PowerXL
RAM05/RASP5 Firmware
Firmware Release Note

- 1 V1.04 RAMO5 Change Notification - 15.07.20204
- 2 V1.04 RASP5 Change Notification - 15.07.20205
- 3 V1.05 RAMO5 Change Notification - 22.10.20218
- 5 V1.05 RASP5 Change Notification - 22.10.20219
- 6 V1.06 RAMO5 Change Notification - 01.05.2023 11
- 7 V1.06 RASP5 Change Notification - 01.05.2023 12
- 8 V1.07 RASP5 Change Notification - 12.05.2023 13
- 9 V1.07 RAMO5 Change Notification - 24.05.2024 14
- 10 V1.08 RAMO5 Change Notification - 29.04.2025 15

5 V1.05 RASP5 Change Notification - 22.10.2021

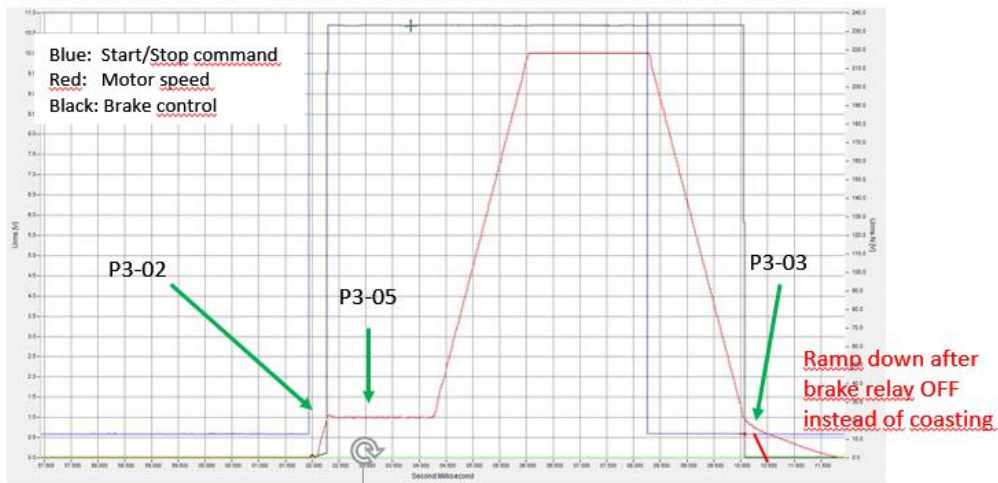
- 1. Reduce the change over time from Ext-24V mode to normal operation**
 In previous release, when drive is powered by external 24V (e.g. ASi) already and mains supply is provided later, it will take about 3.2s for drive to enter normal operation.
 In this new release, the change over time has been reduced to about 2s.

- 2. Add P1-13 function support in 'AUTO' mode for Ethernet/Profinet**
 In previous release, the auto mode operation when P-13 >1 is not fully implemented for Ethernet/Profinet operation as per ASi network.
 In this new release, function has been added with the following definition:
 PLC command off means: control word has no Run command (bit 0 = 0) or Fast stop is active (bit 5 = 1) or Coast stop is active (bit 3 = 1)
 FF1 Reset: FWD = control word direction bit clear (bit 1 = 0), REV = control word direction bit set (bit 1 = 1)

6. Added New Advanced Mode 2 Brake Control Option (P3-01 = 2)

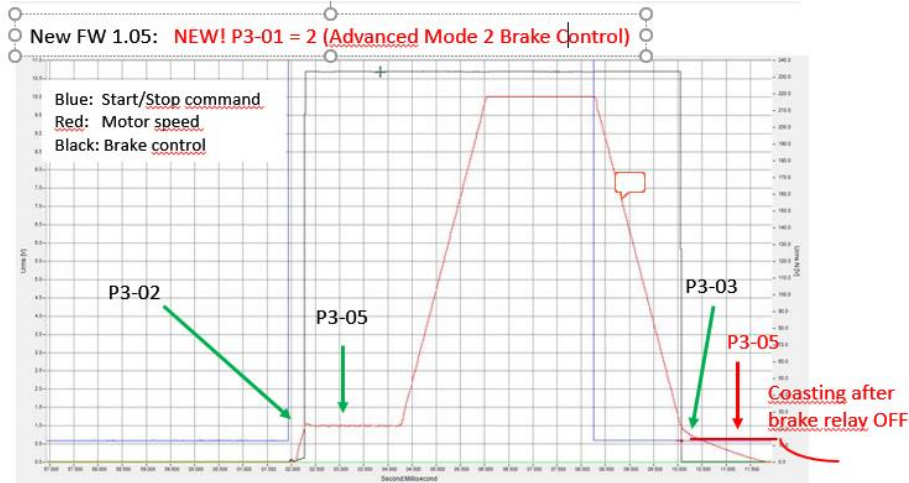
A new option has been added to P3-01 for advanced brake control (P3-01=2).

After receiving a STOP! command, drive will ramp down to Brake Apply Speed (P3-03) and remain at this speed for the time specified on P3-05 waiting for the motor brake to be applied. After this time has expired, drive will coast to stop (C2S).
